On Monday, July 1, 2013, at 5:00 p.m., in Conference Room A, 281 North College Avenue, Fort Collins, Colorado, a City of Fort Collins Hearing Officer will conduct a public hearing to consider a development project in your area. **The project is referred to as the 429 South Whitcomb Street Carriage House, Project Development Plan, #PDP130006.**

STAFF REPORT

PROJECT: 429 South Whitcomb Carriage House Project
Development Plan, PDP #130006.

NORTH ELEVATION
SCALE: 1/4"=1'-0"

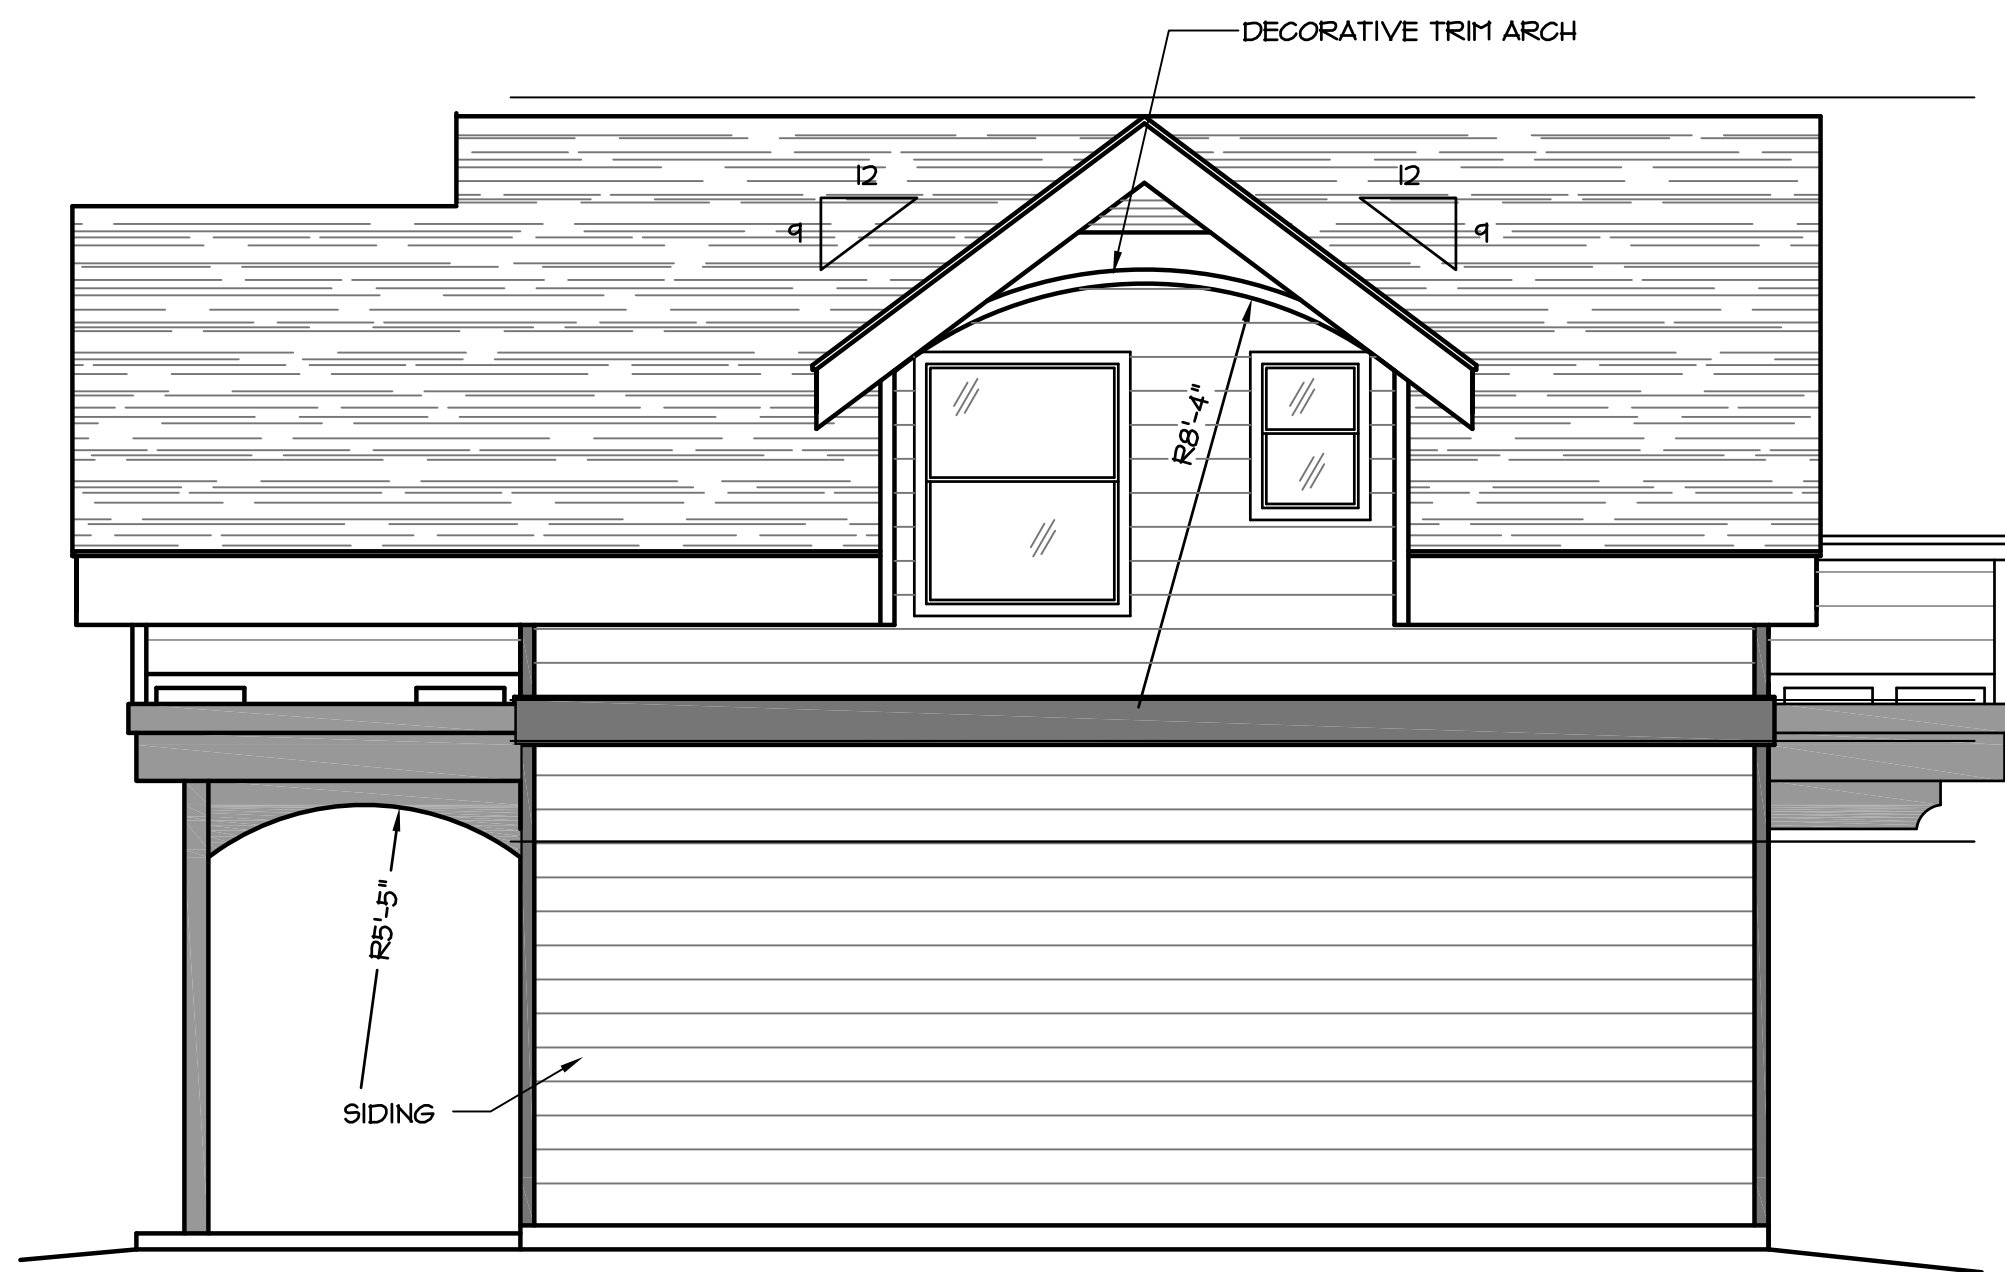
This standard limits the maximum building height for carriage houses to 1 ½ stories. To meet the 1 ½ story requirement, the roof line of the second story must be no more than 3 feet above the second story floor level; the carriage house building design is in compliance with this 3 feet configuration. The project is also in compliance with the maximum building height of 24 feet (4.8(F)(2)(a)(2).

The project is in compliance with all applicable building design standards of this section, which require that buildings be constructed at right angles to the lot, that the primary entrance be located along the front wall of the building, that an accessory building be located at least 10 feet behind the principal building, that the second floor not overhang the lower front or side of the building, that the front

porch proposed is limited to one story, and that the roof pitch is between 2:12 and 12:12.

- The Primary Elements of the proposed architecture – the overall outline of the dwelling, the use of gables and porch elements, and the use of second-story elements that are integrated into the roof line – are designed with a moderate size, bulk, and massing that provide an appropriate transition and compatible fit with existing homes in on the block.

- An appropriate number of secondary elements such as bay windows, porch elements, and roof dormers are provided that are appropriate in size, scale and proportion so that these elements do not overpower the overall building form while providing visual interest and articulated massing on all sides of the home.
